# **RTDI - TECHNICAL SERVICE BULLETIN**

<b>TSB TITLE:</b> Driver Seat - Seat Belt & Anchorages	<b>DATE:</b> 5/15/18
--	----------------------

<b>RTDI BULLETIN NO.</b> TSB-01-18 <b>NHTSA RECALL NO:</b> 17V-182	<b>MODEL:</b> All Stretch Ducks & Truck Ducks
---	---

**REASON:** Replace current driver's seat and seat belt assembly and anchorages with arrangements that have been certified to the requirements of FMVSS 208,209 and 210.

Fig #1

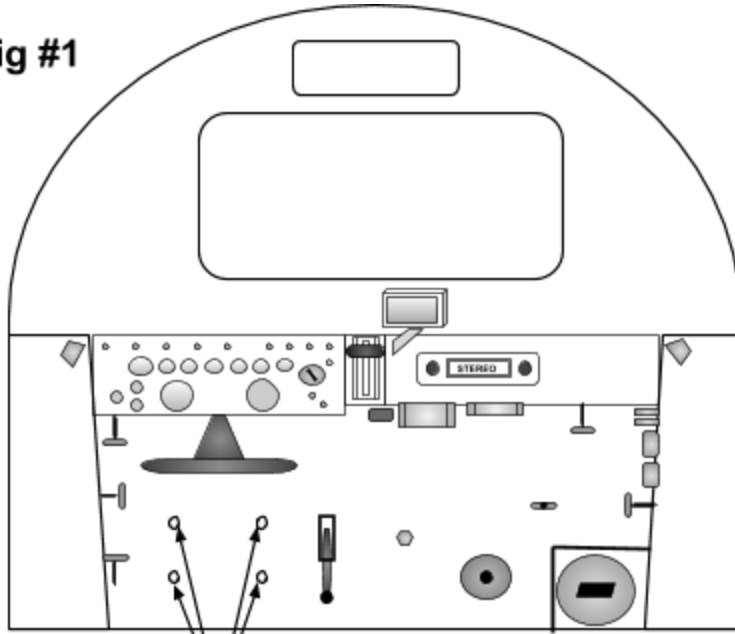
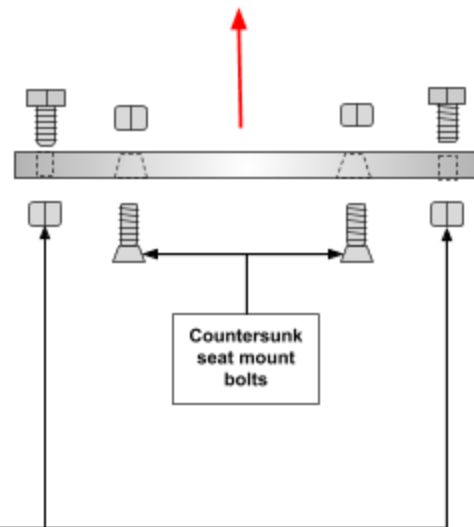
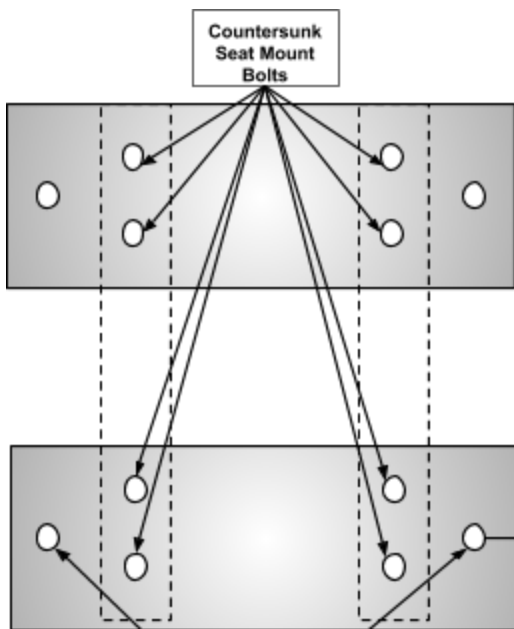
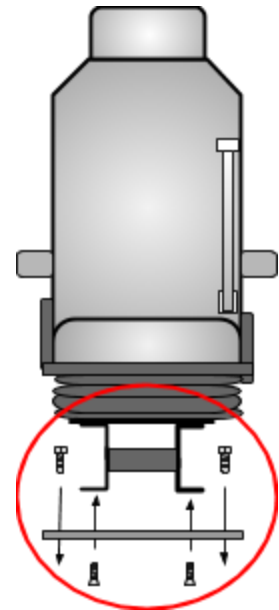
1. Remove current driver's seat and drill out the (4) existing seat mount (floor) holes to ½”.
2. Bolt the ISRI seat to the two steel adaptor plates. Follow instructions in Fig 1. On Pg. 2
3. Bolt the adaptor plate/ISRI Seat to the ½” drilled floor holes.
4. See Pg. 8 for air compressor electrical instructions.

DRILL OUT EXISTING SEAT MOUNT HOLES TO 1/2"

Locate onto the Ducks existing seat mount holes  
NOTE: existing 3/8" holes must be drilled out to 1/2"

Fig #2

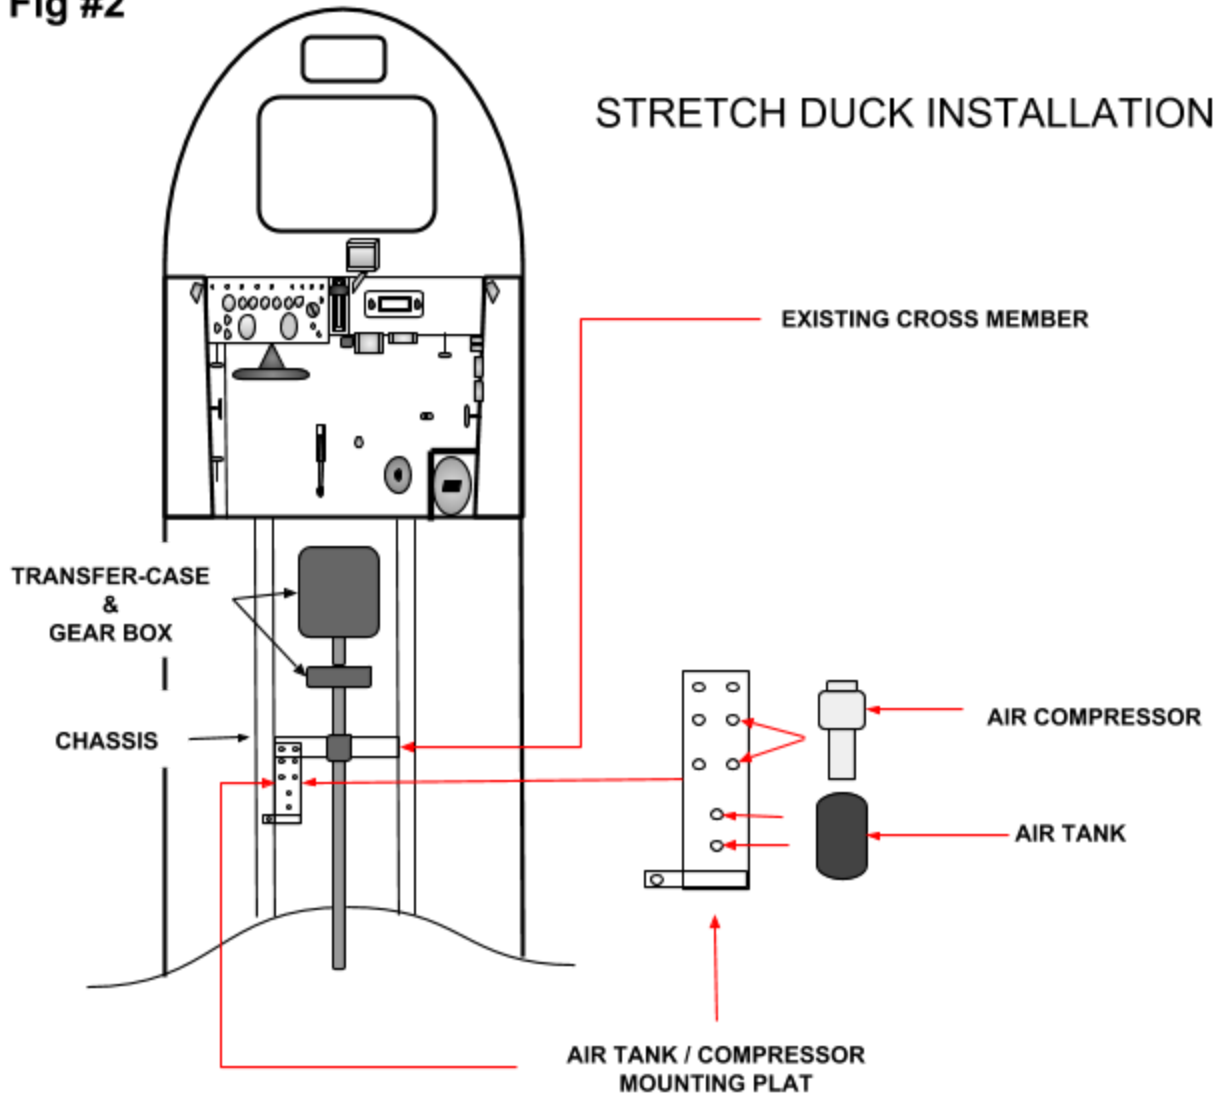
1. Install the Stretch duck air compressor bracket as described in Fig #2 on pg. 3. Truck Duck instruction fig# 3 pg. 4.
2. Before securing tank and compressor onto the bracket, clamp bracket into place and drill the two ¼” holes located on the crossmember and the one ¼” hole located on the chasses.
3. After bracket bolts are properly secured install the air tank and compressor.
4. Run airlines as described in Fig 4. Pg. 5
5. Run electrical wires and provide a 20 amp fuse as described in Fig #1 pg. 8.  
**NOTE:** *Stretch Ducks utilize fuse #34 - Truck Ducks utilize ignition hot open fuse. Ensure the fuse ledger is updated to include the driver seat compressor.*
6. Seat operational instructions pg. 11.
